SOLICITATION AMENDMENT
MODIFICATION DE L'INVITATION

Title - Sujet Ferry Terminal Marshalling Yard Pav	
Solicitation No. - N° de l'invitation EB144-191359/A	Amendment No. - N° modif. 004
Client Reference No. - N° de référence du client R.090692.001	Date 2018-09-27
GETS Reference No. - N° de référence de SEAG PW-\$PWC-008-4340	
File No. - N° de dossier PWC-8-41034 (008)	CCC No./N° CCC - FMS No./N° VME
Solicitation Closes - L'invitation prend fin at - à 02:00 PM on - le 2018-10-02	Time Zone Fuseau horaire Atlantic Daylight Saving Time ADT
F.O.B. - F.A.B. Plant-Usine: <input type="checkbox"/> Destination: <input checked="" type="checkbox"/> Other-Autre: <input type="checkbox"/>	
Address Enquiries to: - Adresser toutes questions à: Reay, D (PWC)	Buyer Id - Id de l'acheteur pwc008
Telephone No. - N° de téléphone (902) 314-7957 ()	FAX No. - N° de FAX (902) 566-7514
Destination - of Goods, Services, and Construction: Destination - des biens, services et construction:

The following changes in the tender documents are effective immediately. This addendum will form part of the contract documents.

Figure 1 - Curb Location Sketch

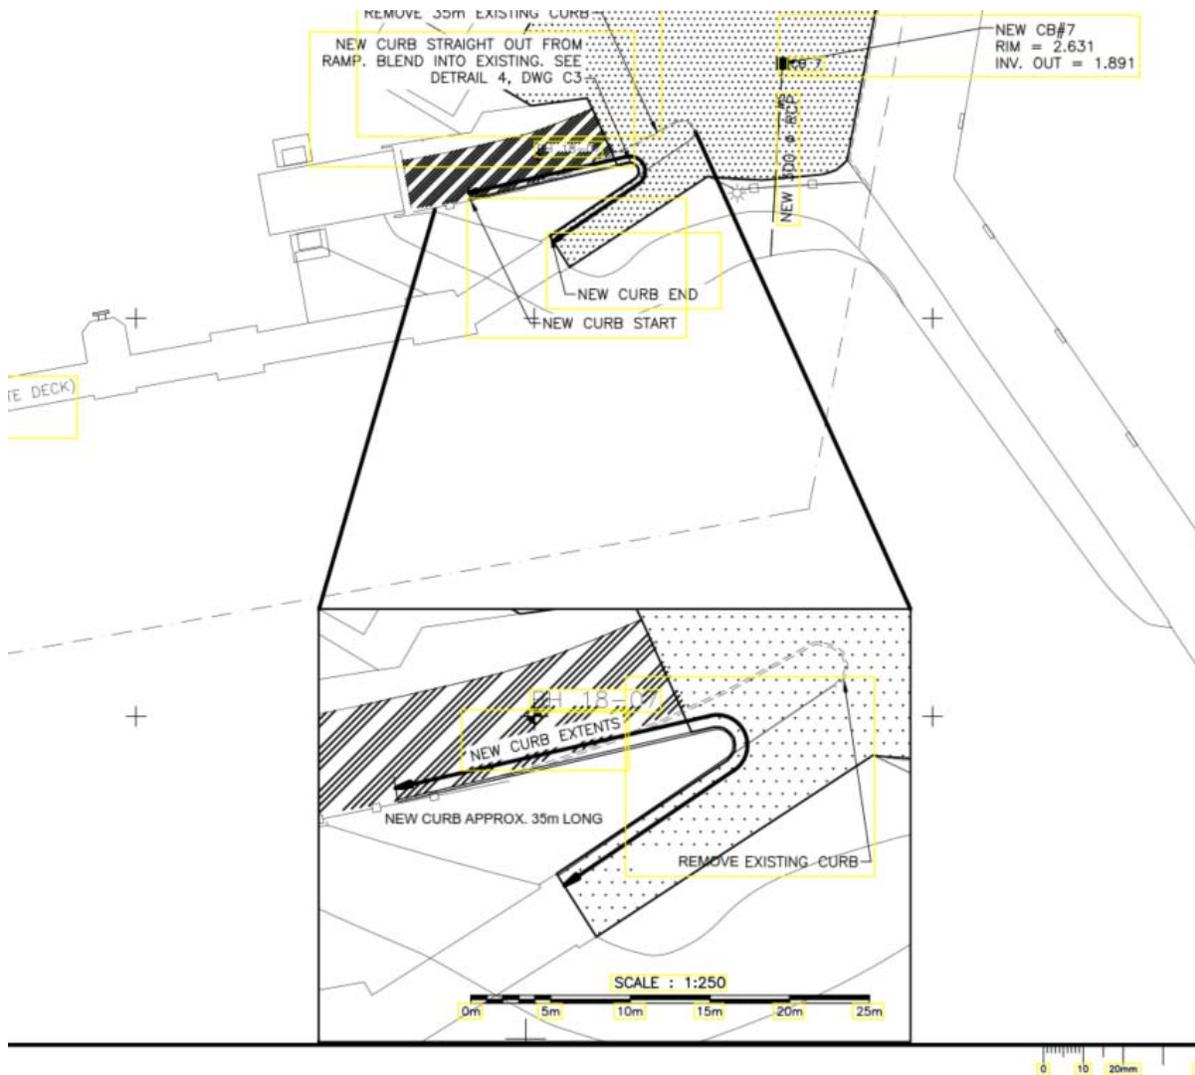
The drawings show a detail for concrete barrier curb but I can't locate in the schedule where it is to be carried in our price. Can you please clarify which spec reference I am to apply this curbing. I also believe it is to be installed around the perimeter of the site is this correct too?

Can you define the limits of the curb to be removed? The drawings are not at all specific. Also, the limits of new curb to be installed and which type. There's two details but only one is referenced in the drawing.

Please include all costs associated with cast-in-place concrete under Unit Price Item #1 (03 30 30 – Cast In Place Concrete). Curb location as indicated on the sketch in this Addendum (Figure 1 - Curb Location Sketch) below.

Please see the attached sketch below (titled Figure 1 – Curb Location Sketch) for the location of the curbs. Please allow 25m in length for Barrier Curb and 10m for Curb and Gutter.
